JOSEPH M. FARLEY NUCLEAR PLANT - UNIT 2
REQUEST FOR ADDITIONAL INFORMATION

Enclosed is Alabama Power Company's response to NRC Reactor Systems Branch question 210.1 item 4 concerning Farley Nuclear Plant Unit 2 containment sump design.

FIG. 1

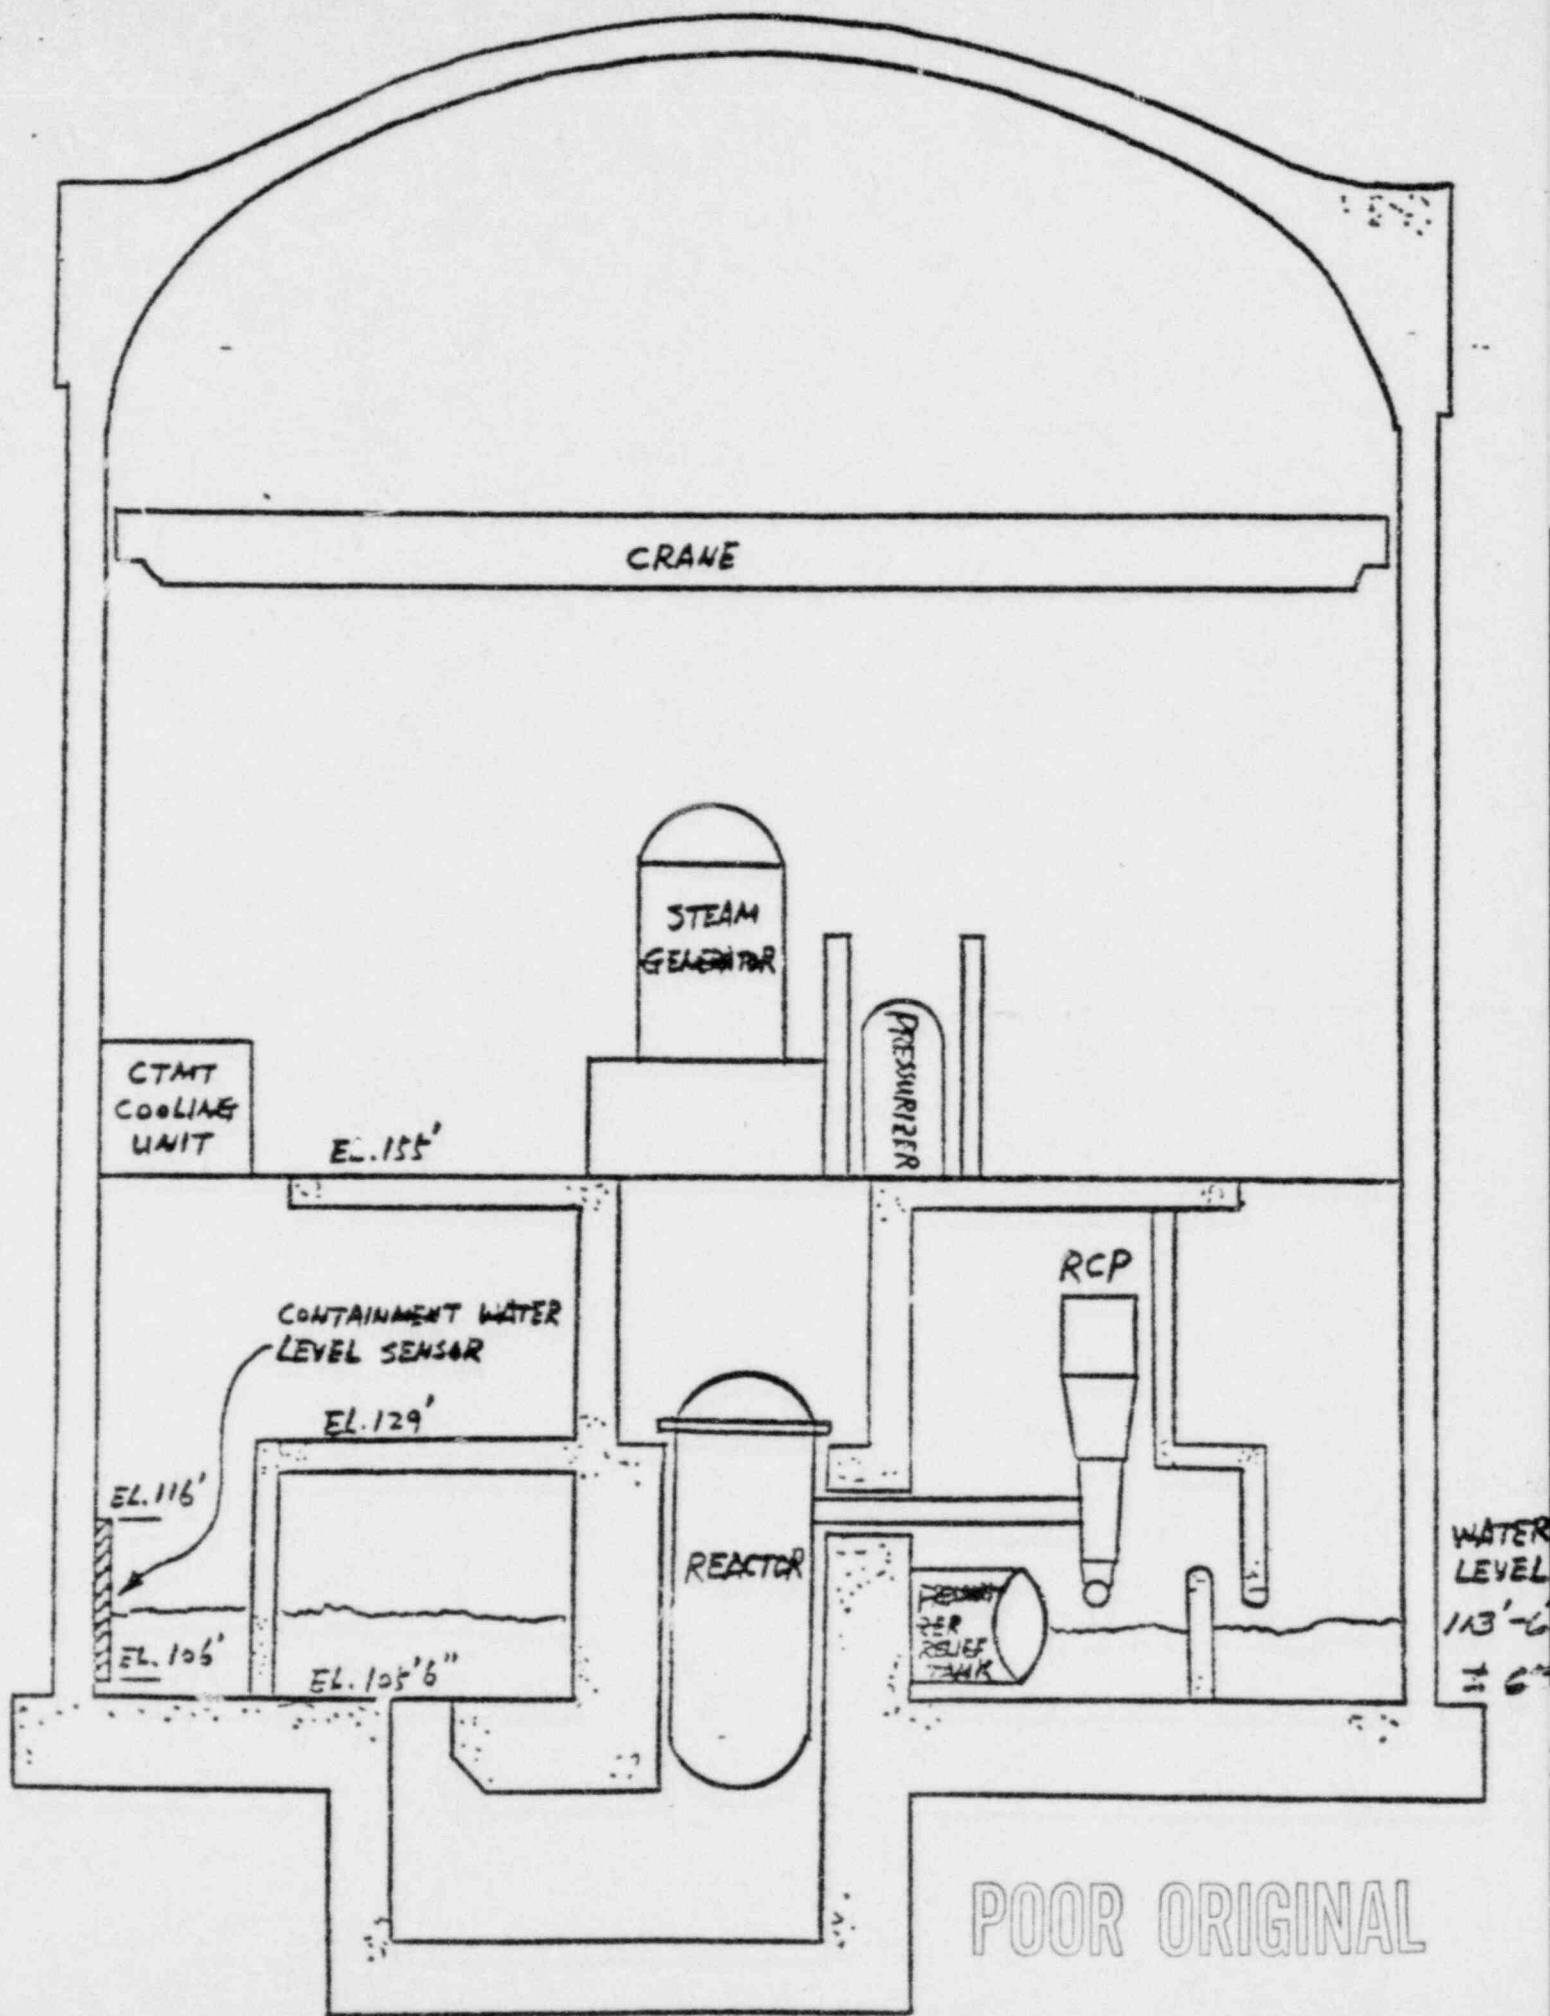
- e. (4) Provide a schematic drawing of the post-LOCA water level in containment during the recirculation mode relative to the elevation of the ECCS sump floor. Include on this drawing the location of the containment water level sensor and the elevations corresponding to readings of zero and 100 percent of range on the control room indicator.
- e. (5) Provide several large scale drawings of the containment structures, systems and components at elevations.
- e. (6) Does Farley utilize similar materials in the containment during power operation for purposes such as reactor cavity annulus biological shielding (e.g., sand tanks or sand bags) or reactor cavity blow out sand plugs?

- e. (4) In Figure 1, Elevations 106' and 116' correspond to readings of zero and 100 percent of range on the control room indicator.

The water level of 113'-6" shown in Figure 1 is a realistic calculation for the post LOCA water level. It is bounded by a maximum water depth calculated for equipment flooding qualification, and the minimum water depth used for ECCS sump performance calculations.
